DOCKETS 50-266 AND 50-301
SUPPLEMENT TO TECHNICAL SPECIFICATIONS
CHANGE REQUESTS 188 AND 189
POINT BEACH NUCLEAR PLANT, UNITS 1 AND 2

Additional information for Technical Specifications Change Requests 188 and 189:

RCS Pressure In Steam Generator Tube Rupture Analysis

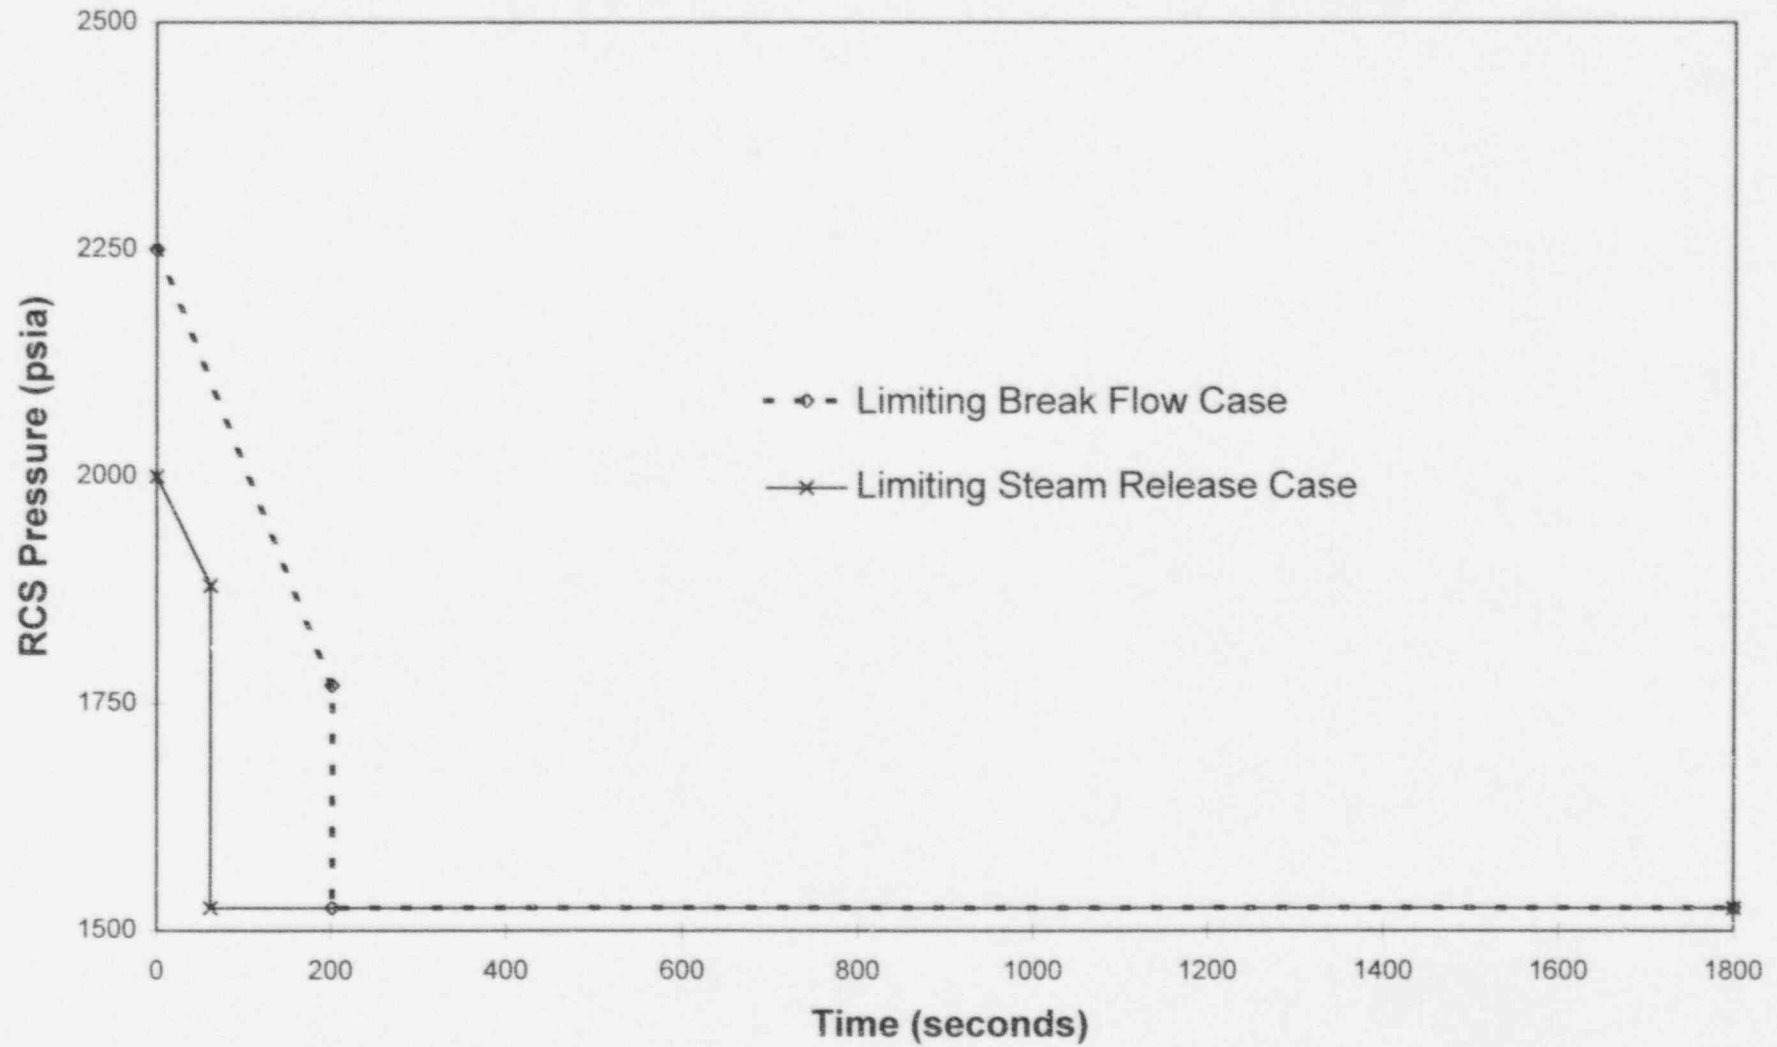
An additional request was made on October 11, 1996 to provide the time sequence of events and pressure response, including the points at which the reactor trip and SI would actuate for the dropped rod, steam generator tube rupture, steam line rupture and small break LOCA analyses. The following information is provided:

3. Steam Generator Tube Rupture

The calculation is not a transient calculation, therefore an RCS pressure as a function of time plot was not generated. The analysis assumes that the transient starts at the nominal RCS pressure and the pressure is reduced linearly to the low pressurizer pressure SI setpoint (1770 psia or 1880 psia, respectively) at the times provided above where SI and reactor trip occur simultaneously. Directly following reactor trip/SI, the pressure is assumed to stabilize at the point where break flow equals SI. This pressure is 1525 psia. This pressure is maintained until break flow termination at 30 minutes. A figure is provided that shows the pressure profiles that were used.
